Application ref: 2022/4196/PRE Contact: Ewan Campbell Tel: +44 20 7974 5458 Email: Ewan.Campbell@camden.gov.uk Date: 19/10/2022

Pre-application Medium Development Pre-application Advice Issued

Address: Former Hampstead Police Station 26 Rosslyn Hill London NW3 1PD

Proposal: Change of use from police station (Sui Generis) to offices on lower ground, ground and part first floor (Class E) and residential on first, second and roof (C3) with private amenity space to provide 5 units, Two four-storey rear extensions of the east wing, full width roof extension, infill extension to the courtyard and alterations to elevations including steps to the front, lifts and wheelchair access

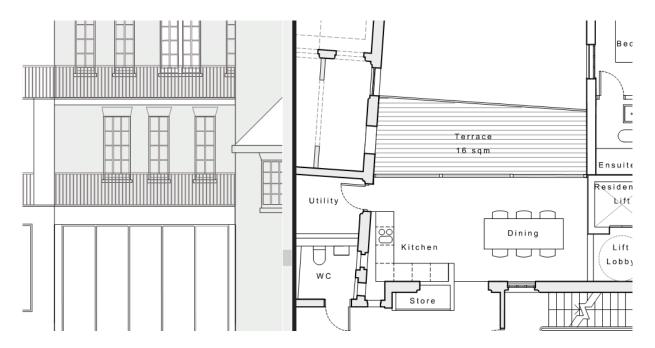
Whilst, for ease, the elements have been broken up in the assessment, the development and architecture needs to relate better to the host building and respond in a more sympathetic manner as a whole. The extensions demonstrate that there needs to be more consideration to what development the host building can take or why the decisions on scale have been taken. For example paragraph 5.6 of the Heritage Statement states: To the rear of the building, repair and refurbishment works are proposed to all elevations, whilst extensions are proposed to the rear eastern wing at lower ground, ground, and first and second floor level. Where extensions are proposed, these are to be constructed from a contextual material, matching the red brick of the existing building, whilst maintaining a clear distinction between old and new through the use of modern glazing and balconied areas secured by contextual iron railings. New sash windows are proposed to match those seen across the façade, creating degree of order to the rear elevation of the eastern rear wing (currently comprising blocked up openings and an irregular fenestration pattern).

This only goes into the materials in any sort of detail and reinforces the point that, whilst it is accepted that rear extensions could go on the site, there needs to be a more proportionate balance between heritage concerns and GIA uplift.
